Grey Tank Supports May Contact Fuel Tank

Bulletin Type:	Recall	Publication Date:	March 2025
Bulletin #(s):	25V-072 USA 2025-057 Canada	Make(s):	Jayco & Entegra Coach
Job Code(s):	9903619	Model(s):	Launch, Launch LE, Terrain, Terrain LE
Flat Rate(s):	9903619 .50 HR Grey Tank Support Replacement	Model Year(s):	2021-2025

Incident:	Grey Tank Supports May Contact Fuel Tank
Affected Units:	2021-2025 Jayco Terrain, Terrain LE & Entegra Coach Launch, Launch LE
Parts Kit:25V-072	Parts Kit #: 25V-072 X2 -- U-CHANNEL,AL .50X01.50X11GAX15.00 W/TB BLK .44 HOLE (0.144.005) X1 -- U-CHANNEL,AL .50X01.50X11GAX15.00 W/.44 HOLE (0.118.346) X3 -- BOLT,L .38X8.00 ZC (Exterior Side of Coach) X3 -- BOLT,L .38X12.00 ZC (Interior Side Coach) X6 -- WASHER,FL .38 ZC USS X6 -- NUT,HEX LK NYL .38-16 ZC
Misc. Tools & Supplies:	Ratchet or Impact Socket – 9/16” Deep Well Grease Pencil Zip tie Pry Bar
Parts Return Information:	N/A

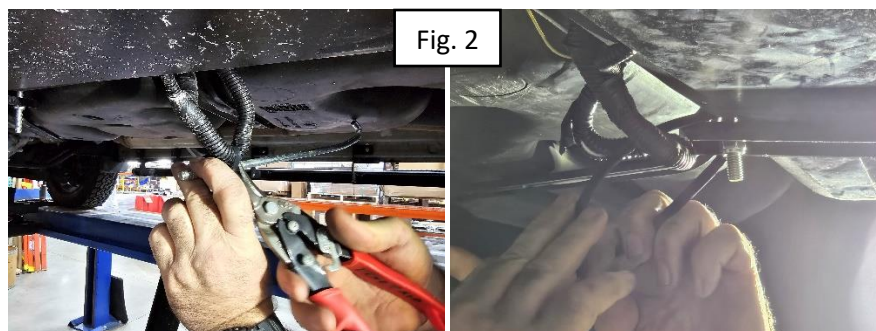
8. Take down the original center bracket and bolts and replace with the new bracket and bolts (with tube). **Note: The top of the bracket tube should be resting against the bottom of the tank.** (Figure 4)
9. With the bracket in place, re-secure the nuts and washers onto the bolts to fasten the bracket in place. **Note: You will want to hand tighten the nut and washer on the bolt to prevent cross threading. Then use an impact or ratchet to tighten until snug. Do not fully secure the tank bracket as this will be done in a later step.**

Fig. 5

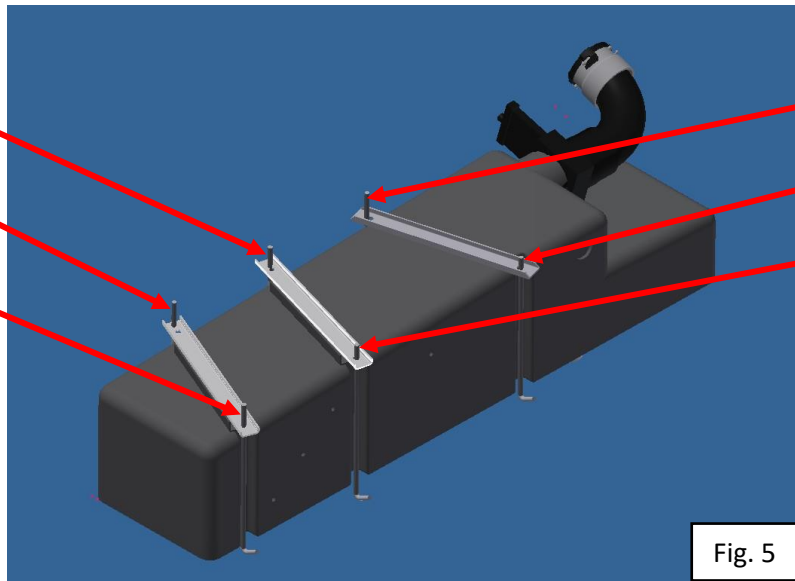
13. With all the brackets changed out, you will want to go back and fully secure all of the nuts on the bolts. Each should be torqued to 35IN-LBS. (Figure 5) **Note: Be sure to torque the bolts in an alternating pattern.** (Figure 6)
